**BID-TIME ADDENDUM # 1**

December 2, 2022

Murrieta Elementary School  
Murrieta Valley Unified School District  
App. # 04-119432, File # 33-32

DLR Group | BakerNowicki Design Studio  
731 Ninth Avenue, Suite A  
San Diego, CA 92101

# 4017 MURRIETA ES - SITE UTILIZATION PLAN 12/1/2022

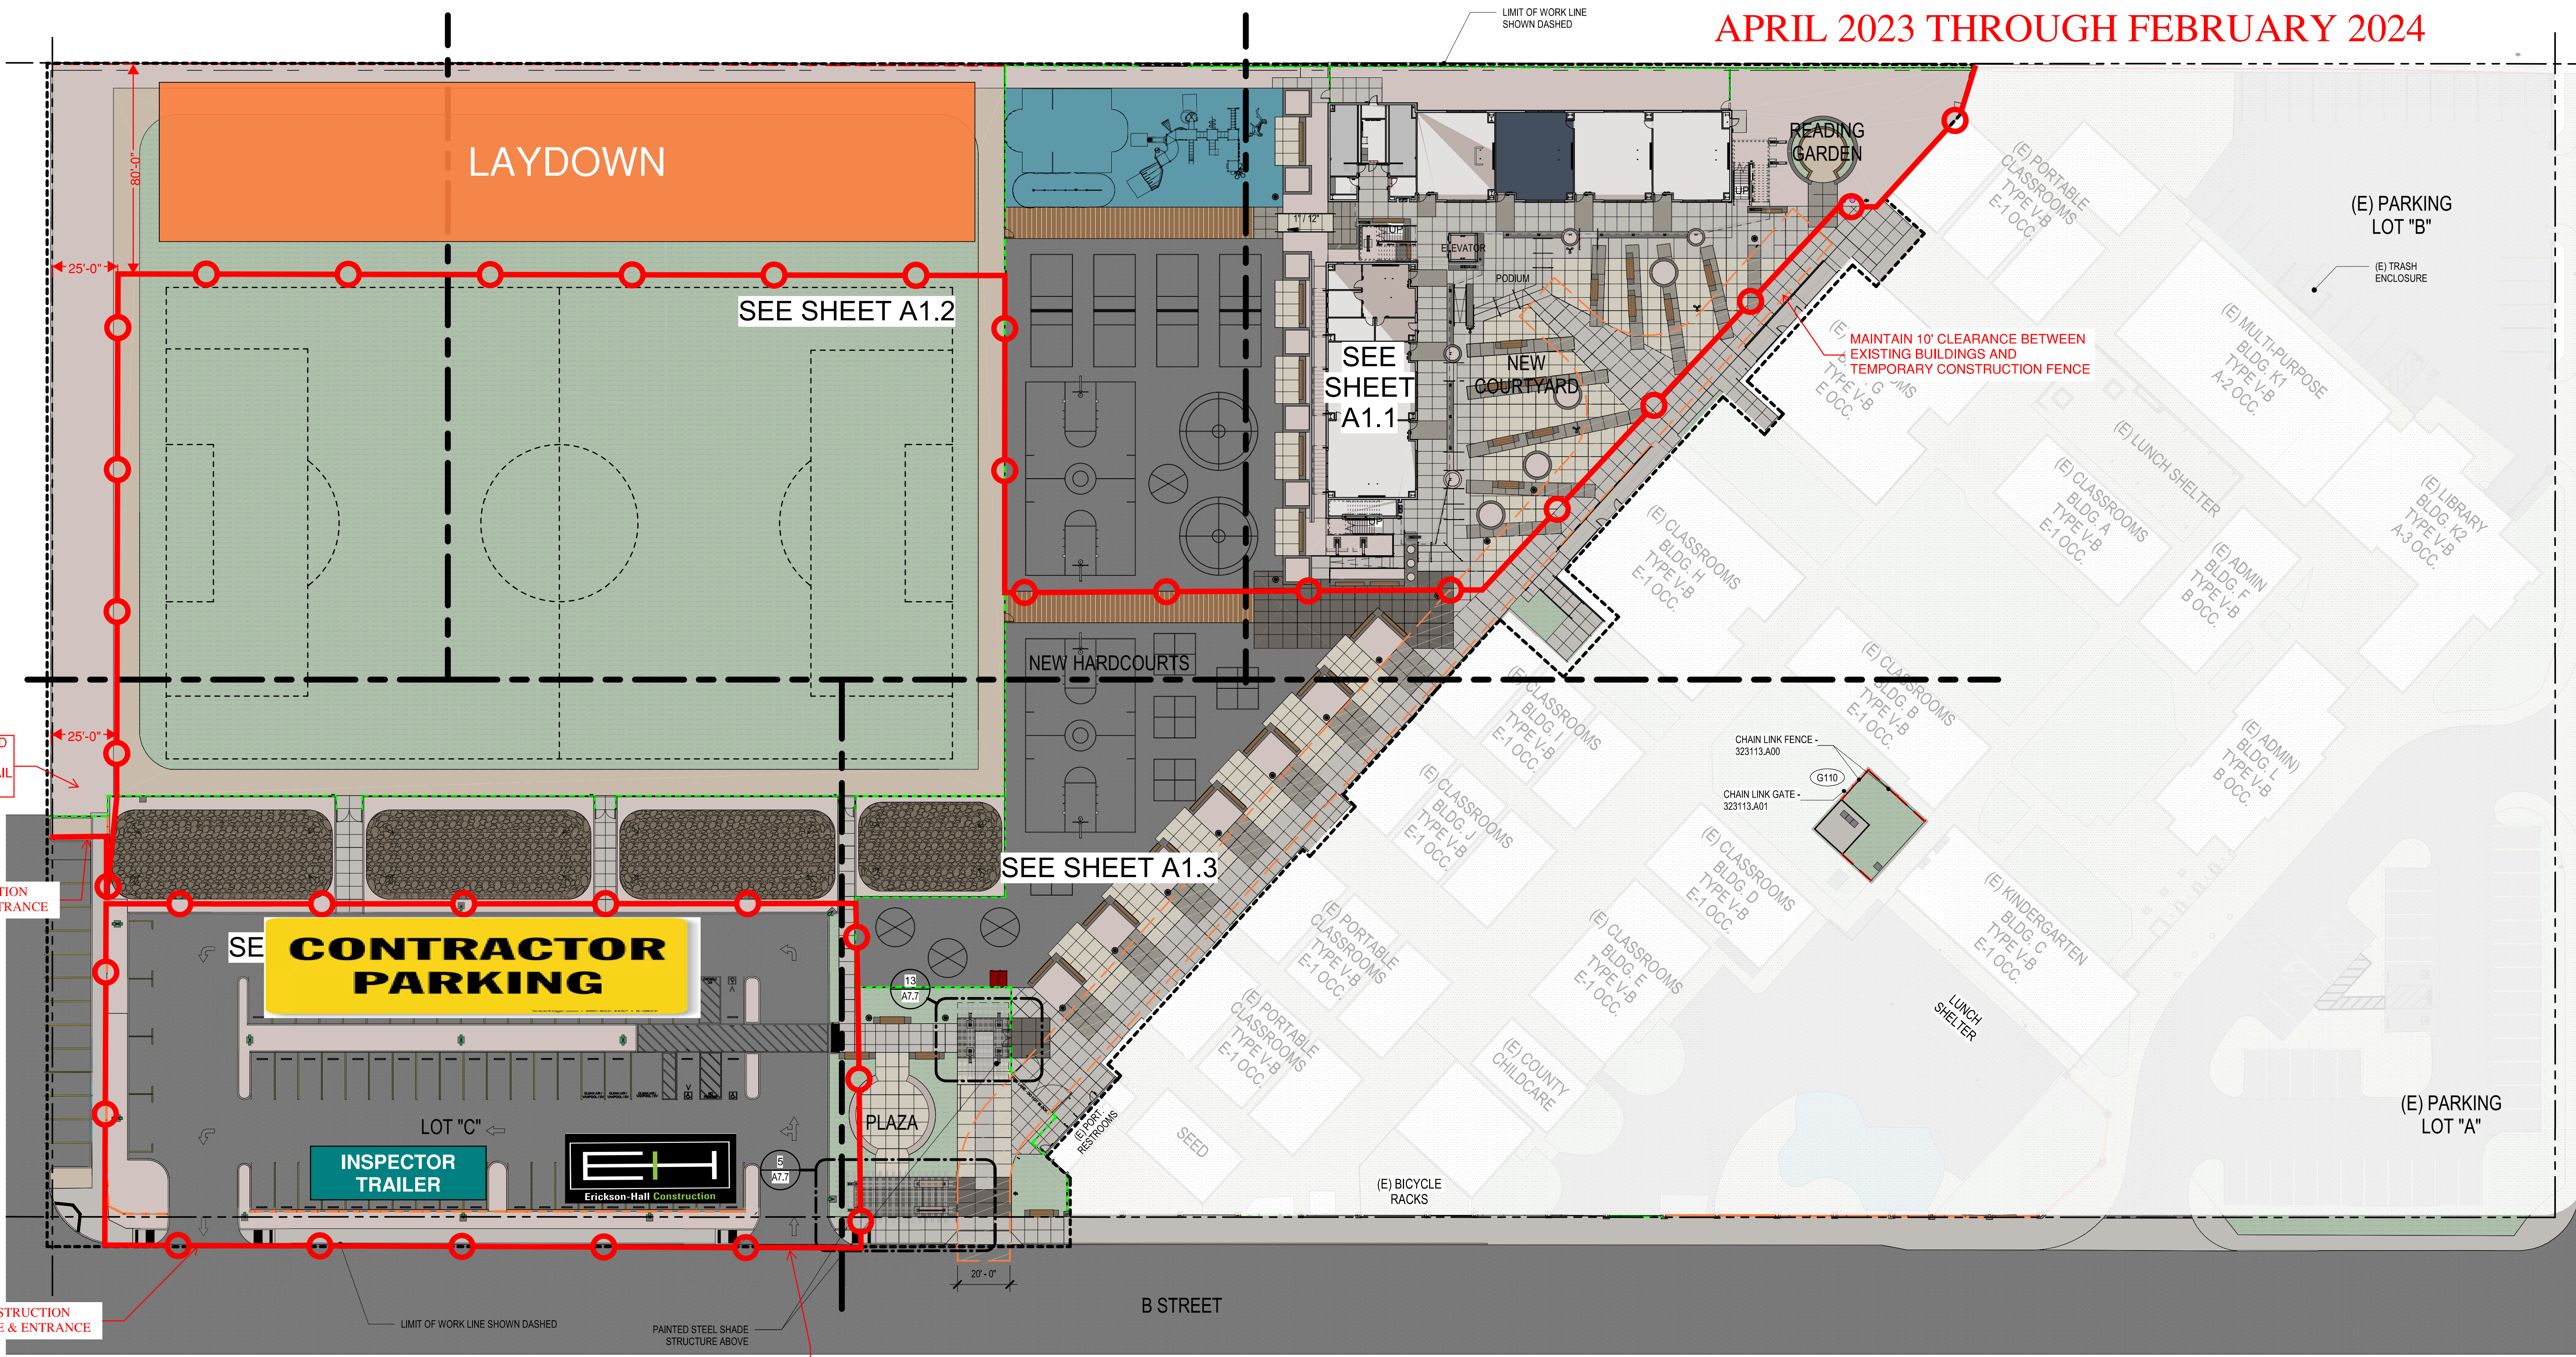
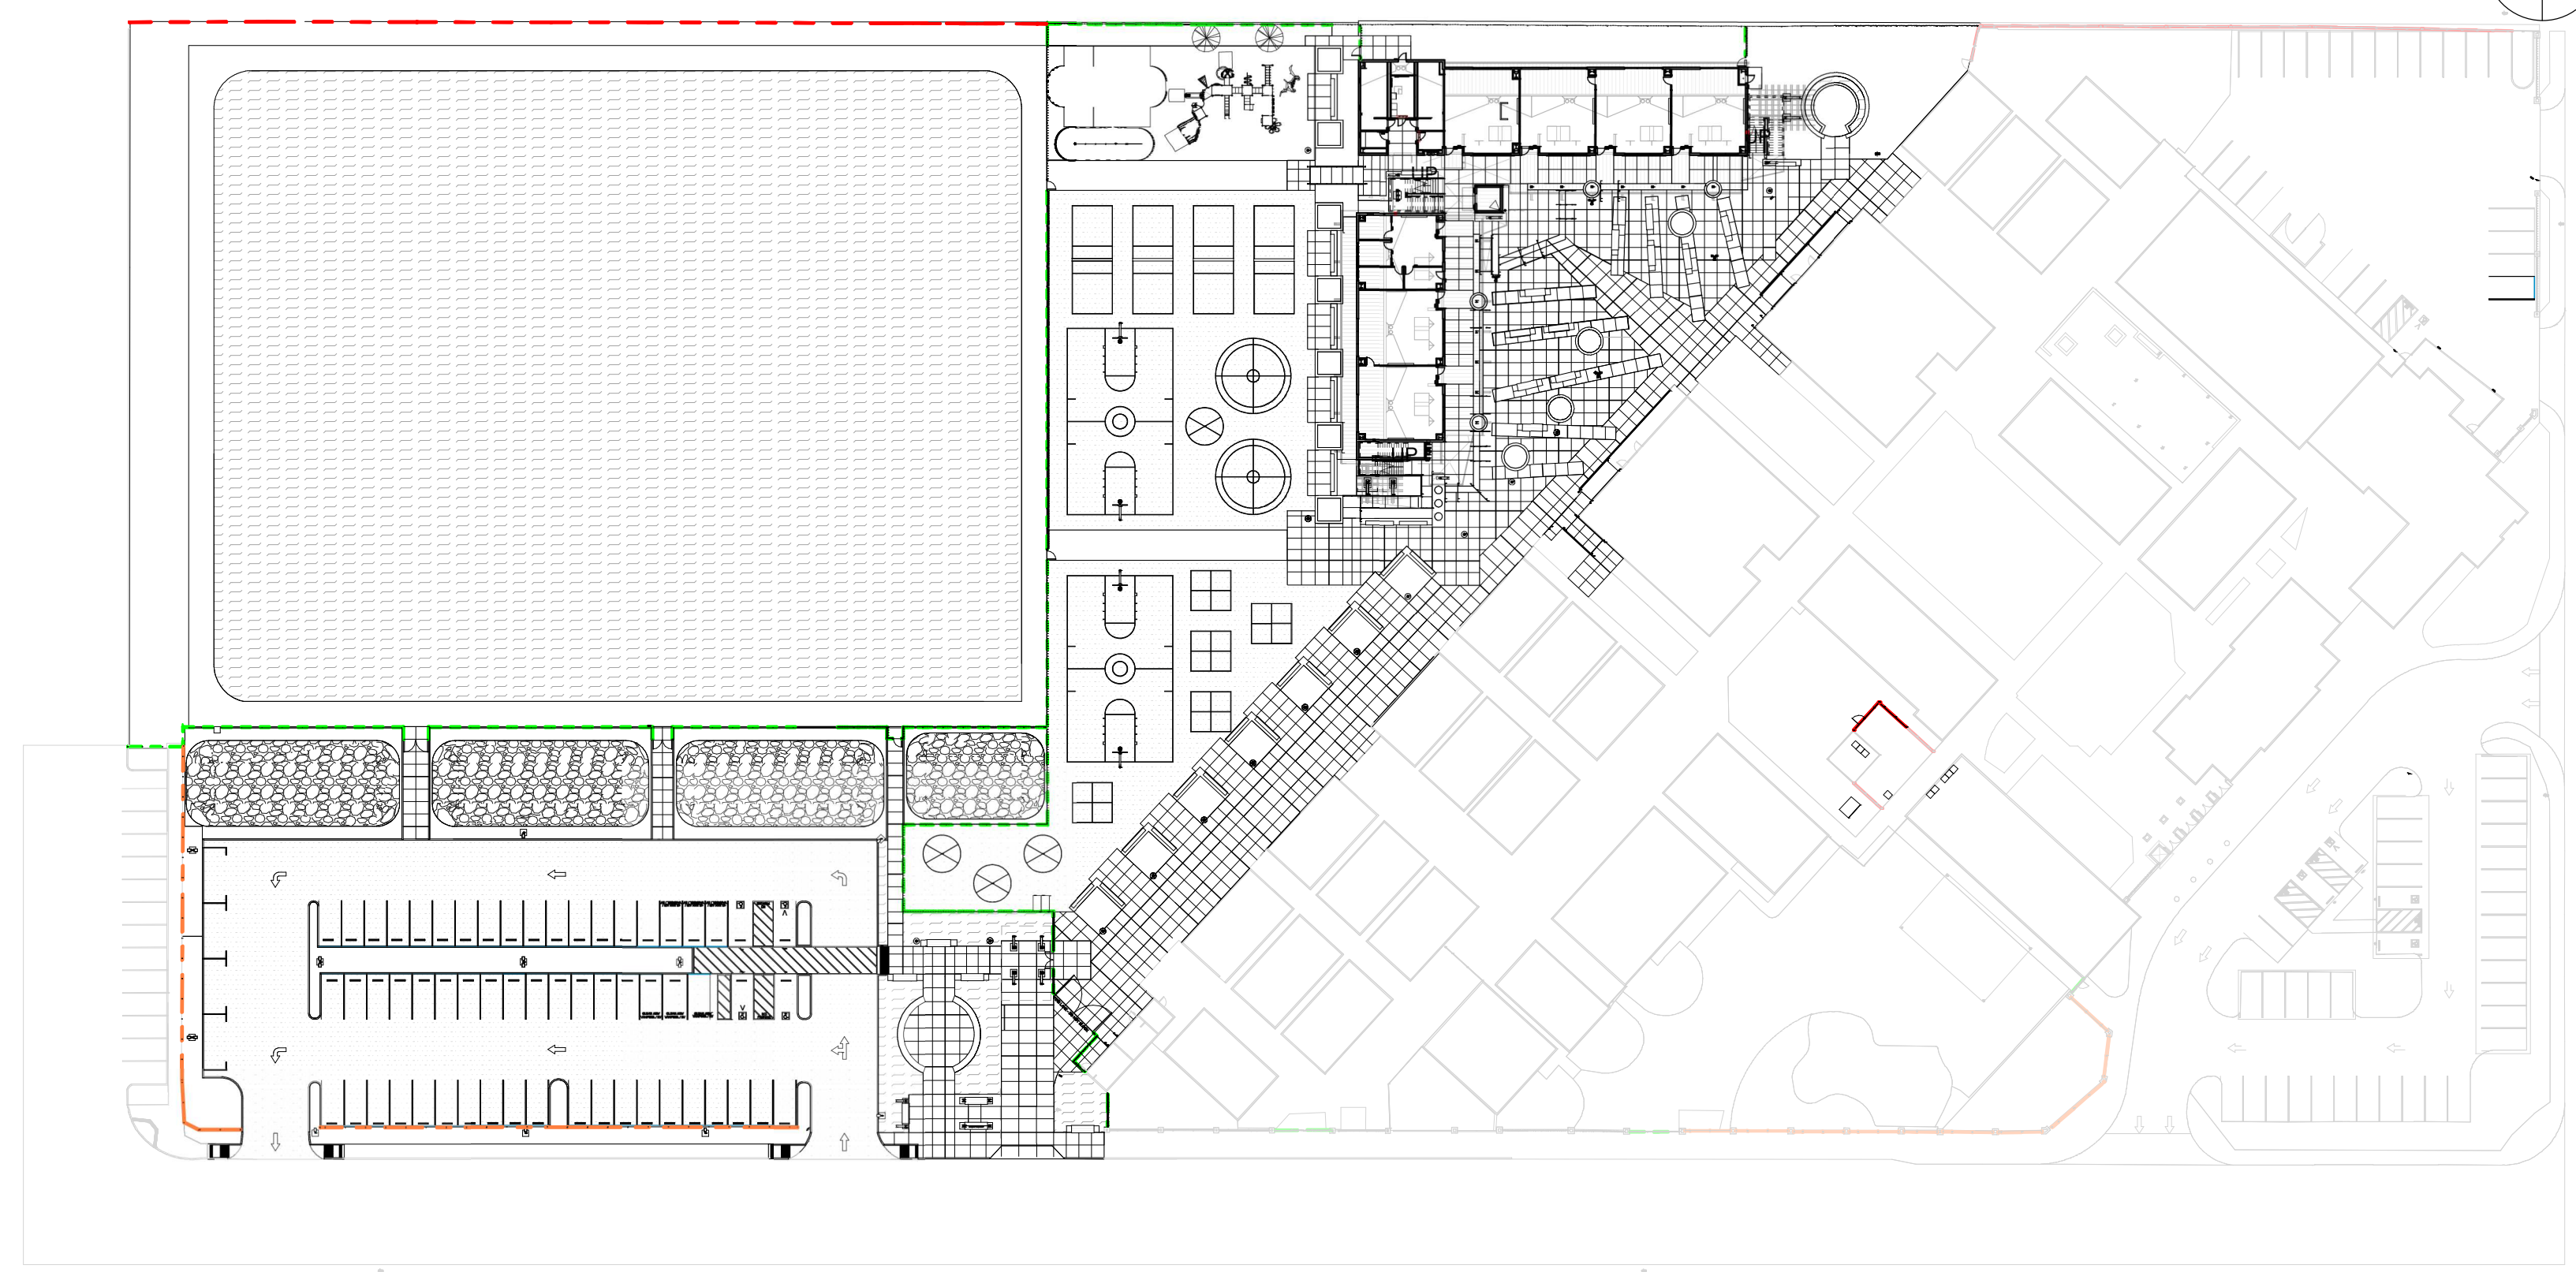
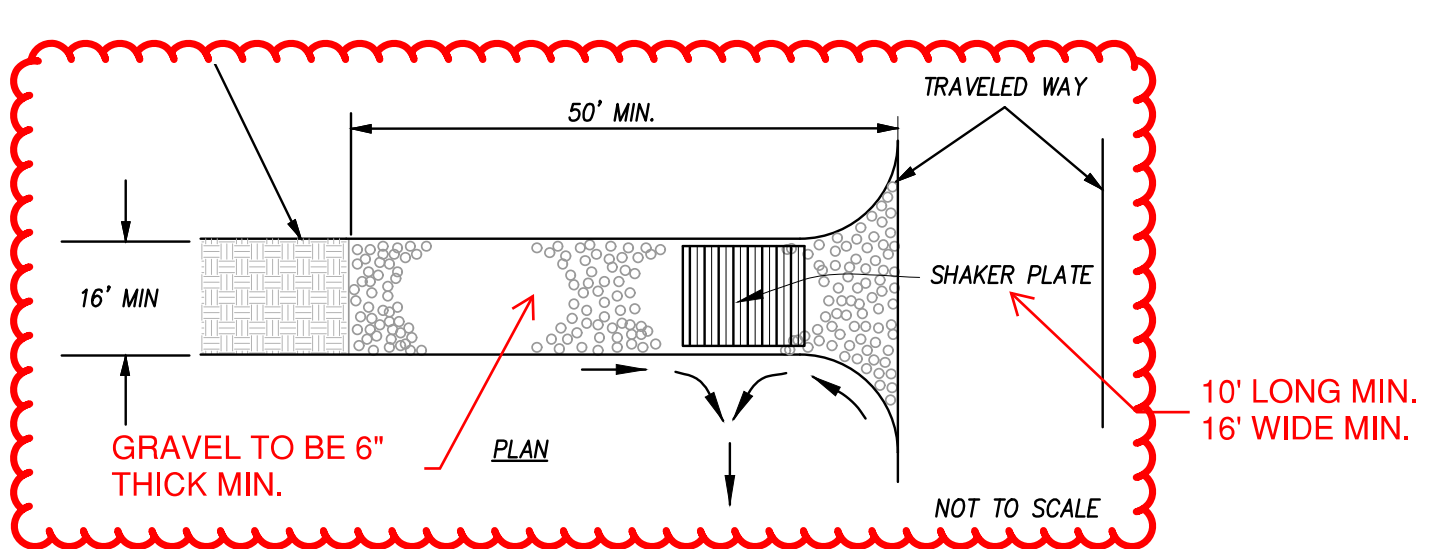
- A. Schedule was not originally included in contract documents, but is incorporated into the contract documents via this bid-time addendum 01. See attachments section for preliminary construction schedule and phasing plan.
- B. Site utilization plan is also attached and therefore incorporated into the contract documents. Information included in the site utilization plan is as follows:
- a. Installation and relocation of temporary fencing, and construction gates per phasing of project to be included in BP#1. Whenever possible temporary fencing will need to be secured to the ground via stakes in lieu of sand bags. Coordinate with CM Superintendent for direction on when and where this condition will occur.

- b. Installation and relocation of CM and Inspector trailers for temporary utilities connection and disconnection as needed. Furnishing and installing temporary electrical to construction trailers to be included in BP#15. Disconnect, hook-up and relocation as directed by CM Superintendent.
- c. PTC Storage Area
- d. PTC Parking Areas
- e. Construction Entrance requirements for BP#1.
